# PLAN COMMISSION

December 11, 2023 at 5:30 PM

- A. Review of Site and Architectural Plan for 1509 Washington Street, submitted by Adam Stein of Logic Design & Architecture, Inc.
- B. Review of additional materials submitted for Conditional Use Permit application for use of self-storage units on 15<sup>th</sup> Street, for parcel 053-000-076-015.03, submitted by Alliance Construction and Design and Eric Burrows (owner).
- C. Review of request to change the sign ordinance to permit signs placed onto sidewalks.

**Action:** Site and Architectural Review, 1509 Washington Street, 0.643 acres

ARCHITECTURAL SITE PLAN

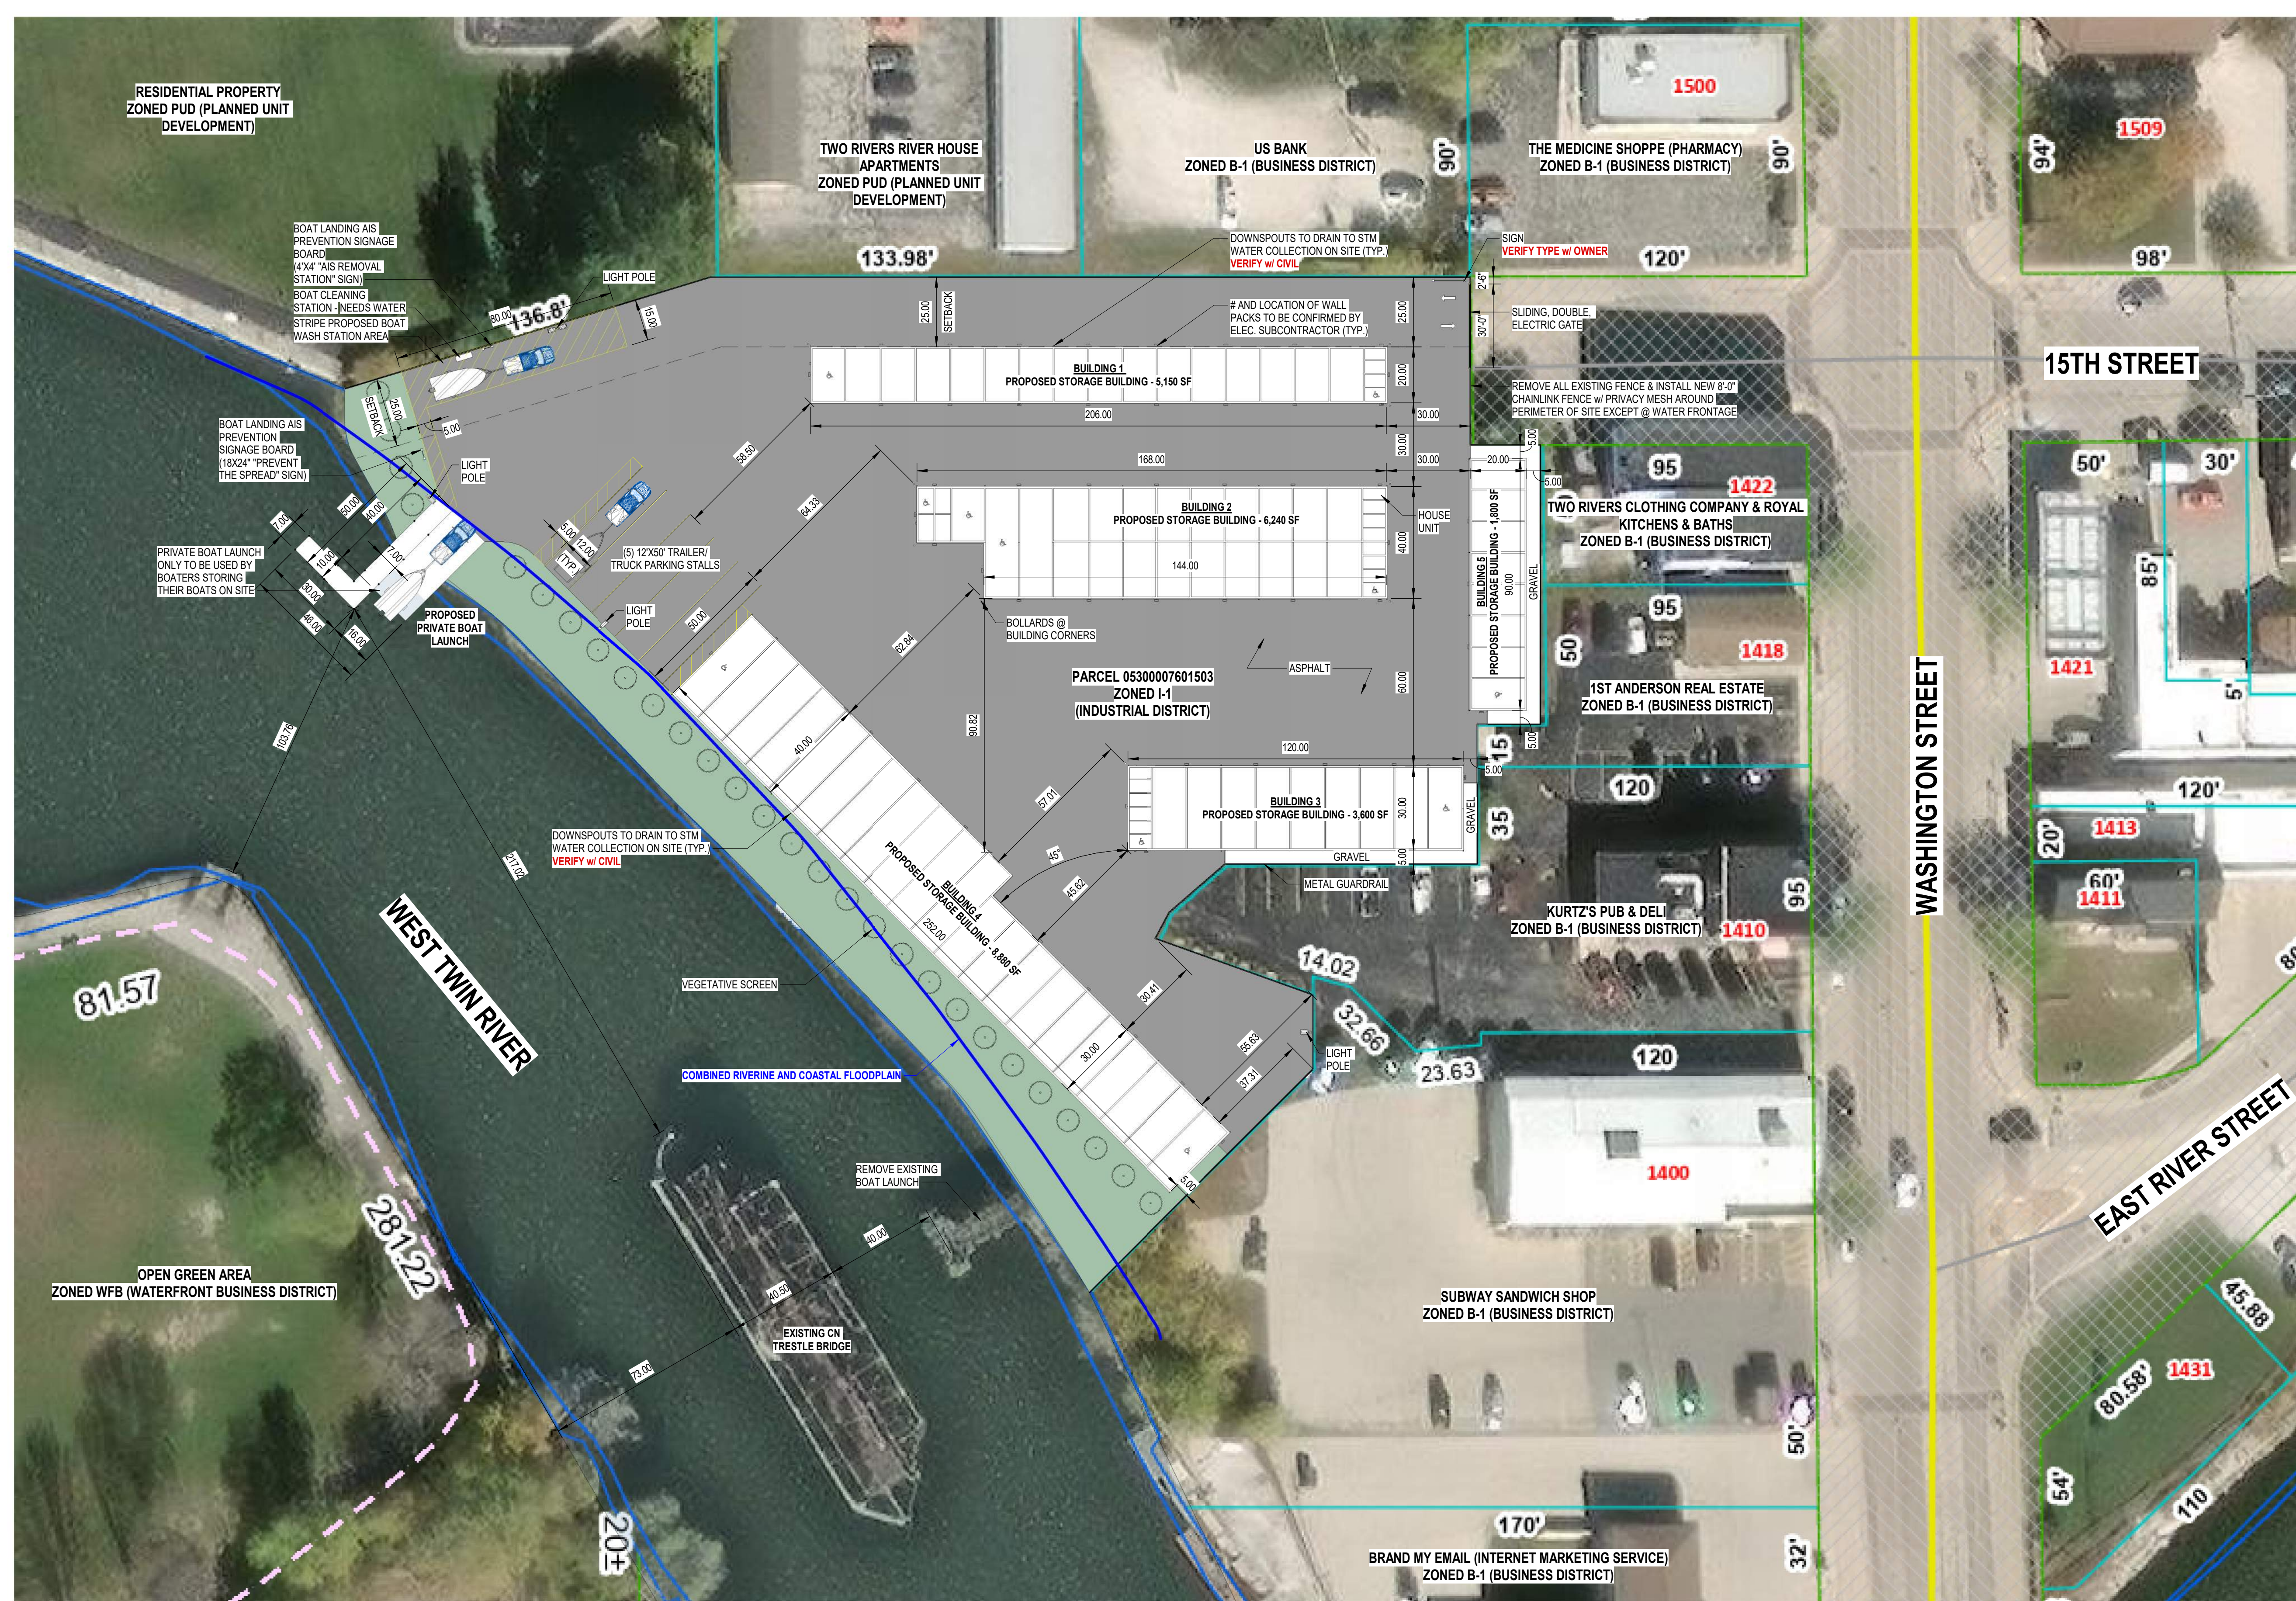
6. The site plan does not show the 25-foot setback requirement from the Planned Unit Development (PUD) zoned parcels to the north.
7. The number of storage units, and the proposal overall, will necessitate a stormwater management plan for review and approval by the City of Two Rivers and the state.

6. The site plan was revised to meet the 25'-0" building setbacks from the PUD zoned parcels to the north.
7. A stormwater management plan for review and approval by the City of Two Rivers and the state will be prepared by Christian Moring, PE, from Stantec for the site plan approval after we have CUP approval to move forward with this development.
8. A grading plan for review and approval by the City of Two Rivers and the state will be prepared by Christian Moring, PE, from Stantec for the site plan approval after we have CUP approval to move forward with this development.
9. The site plan was revised to show a vegetative screen at the waterfront. A site plan will be completed for the site and architectural review process after we have CUP approval to move forward with this development.

FIRE TRUCK TURNING

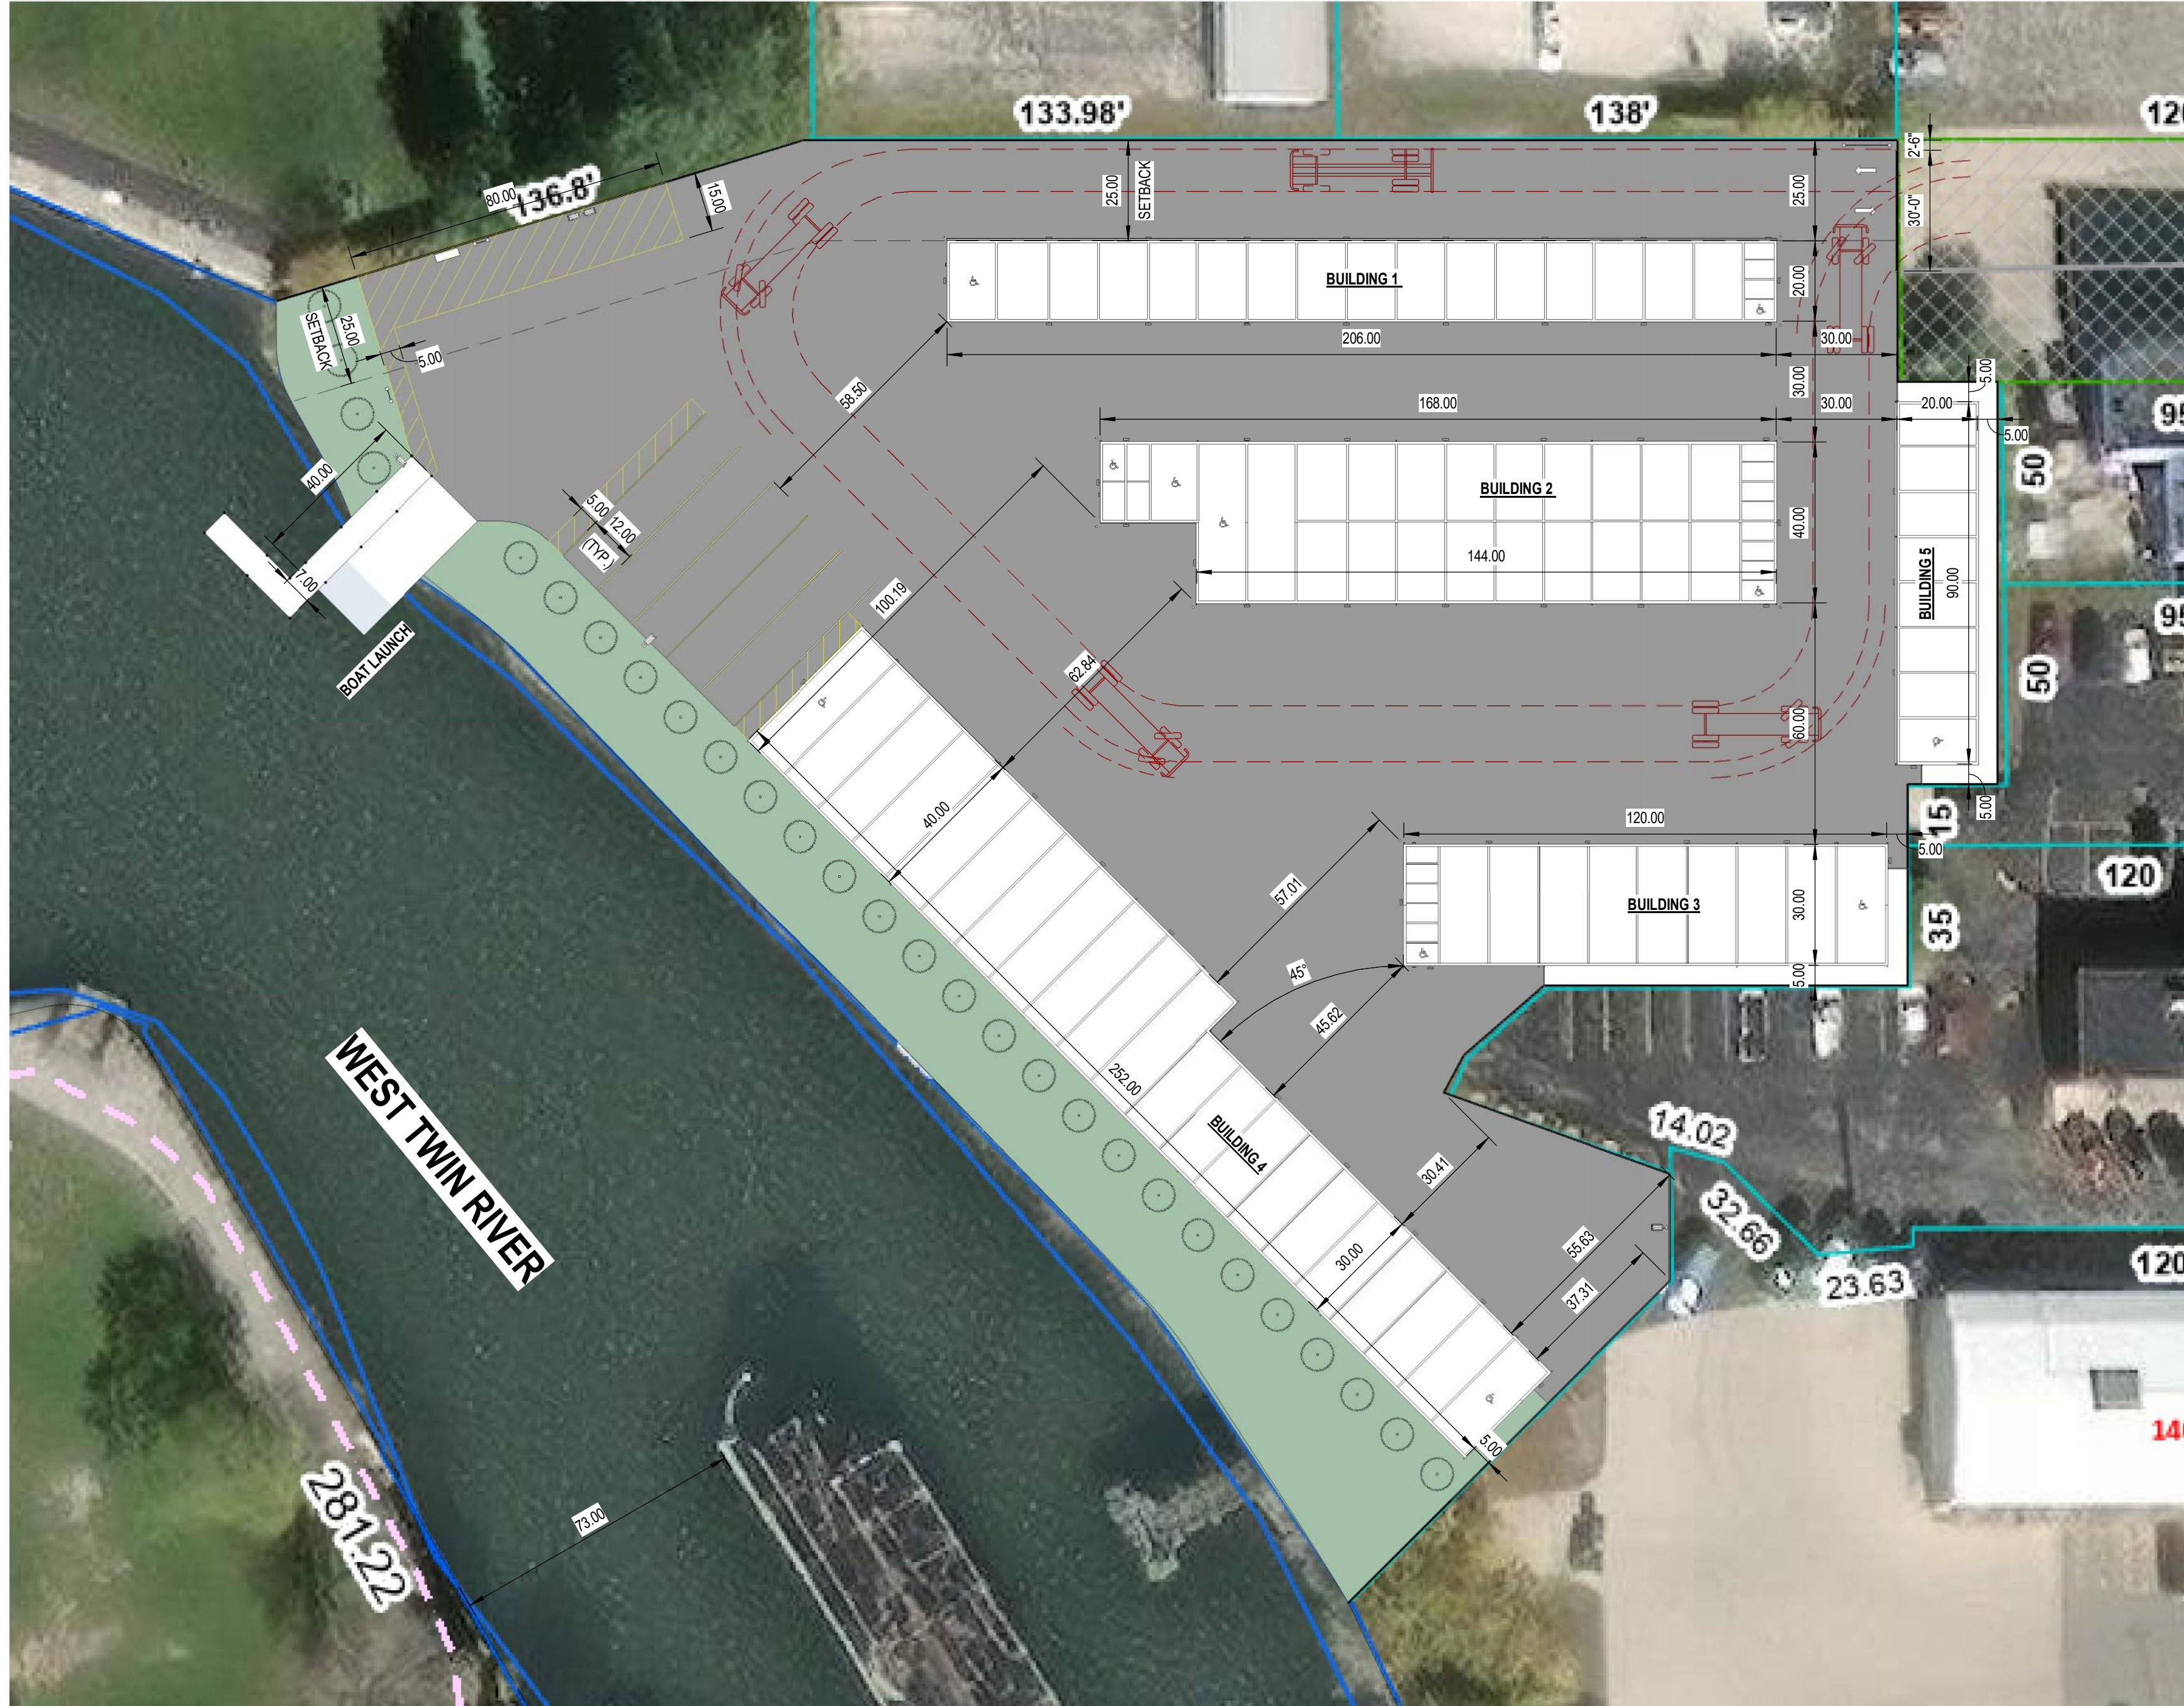
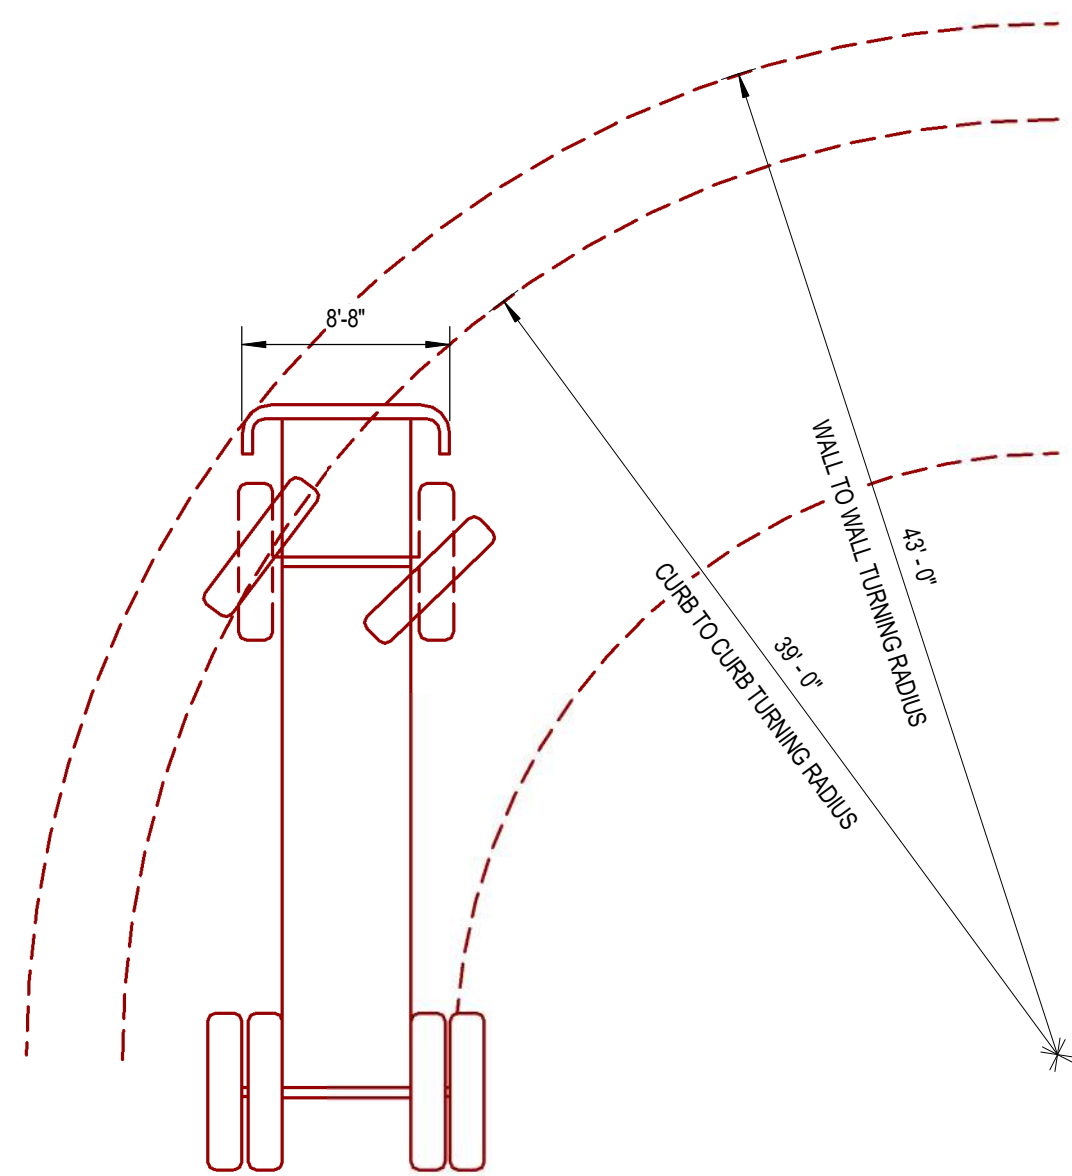
3. The slope of the boat ramp itself and its condition.
4. The existence or status of a boat ramp permit with the WI DNR.
5. The preliminary plan layout does not appear to show enough area for vehicles with boats or trailers to turn or maneuver to access the storage units or to maneuver to access the boat ramp. This is also the case for fire trucks to access the site and boat launch area.

5. The site plan was altered to provide a 30'-0" drive aisle between buildings 1 and 2 due to the smaller size of the units that are off of that 30'-0" drive aisle. The 30'-0" is industry standard for aisles between storage unit buildings housing units with sizes of 12'x20' and smaller. This similar condition is proposed between buildings 2 and 5. 60'-0" of space is provided between buildings 2 and 3 for adequate maneuvering of vehicles with trailers. A minimum of 90.86' is provided in front of the 2 large, 12'x40' storage units in building 2. A minimum of 57.01' is provided in front of the 6 large, 12'x40' storage units in building 4. The truck with trailer turning and maneuvering on site is shown on sheet A053 in the documents included with this narrative. The fire truck turning and maneuvering on site is shown on sheet A052 in the documents included with this narrative. The fire truck turning radius is based off the largest truck the City of Two Rivers Fire Department has. The turning radius information was received from Chad Kakes, Assistant Chief of Fire Operations for the City of Two Rivers Fire Department, and is also included with the submitted documents.
